Bulletin No :  
CM-23-047-02-KEEN  
Date : Feb. 09, 2024  
Ref.PB No :

**ENGINE STOP SOLENOID FAILURE V2.1**

**MODEL : K008-5, U10-5, U15-3, U17-3a, KX015-4, KX016-4, KX018-4, AND KX019-4**

**REASON FOR REVISION :**

## 1. Removing the engine stop solenoid

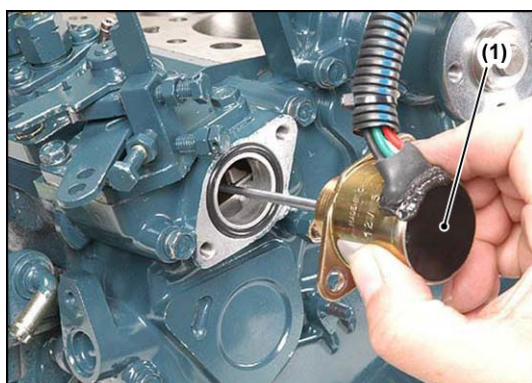
1. Remove the engine stop solenoid (1) according to the engine WSM.

- 1 ENGINE, SERVICING
  - > 4.CHECKING, DISASSEMBLING AND SERVICING
  - > [2] DISASSEMBLING AND ASSEMBLING
  - > (4) Gear Case and Timing Gears, Injection Pump, Fuel Feed Pump and Speed Control Plate
  - > Point 1

## 2. Installing the new engine stop solenoid

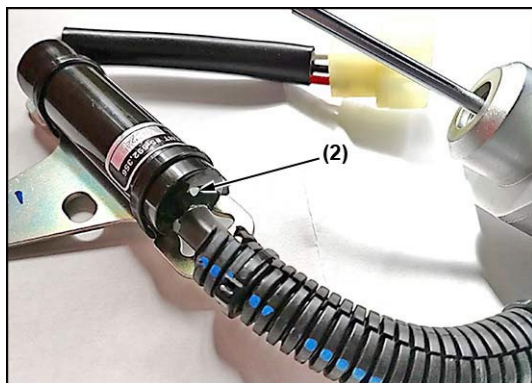
1. Install the new engine stop solenoid (1) according to the engine WSM.

- 1 ENGINE, SERVICING
  - > 4.CHECKING, DISASSEMBLING AND SERVICING
  - > [2] DISASSEMBLING AND ASSEMBLING
  - > (4) Gear Case and Timing Gears, Injection Pump, Fuel Feed Pump and Speed Control Plate
  - > Point 7
- The new engine stop solenoid (1J022-60020) has the white marking (2).

(1) Engine stop solenoid: 1J022-60020

(2) White marking
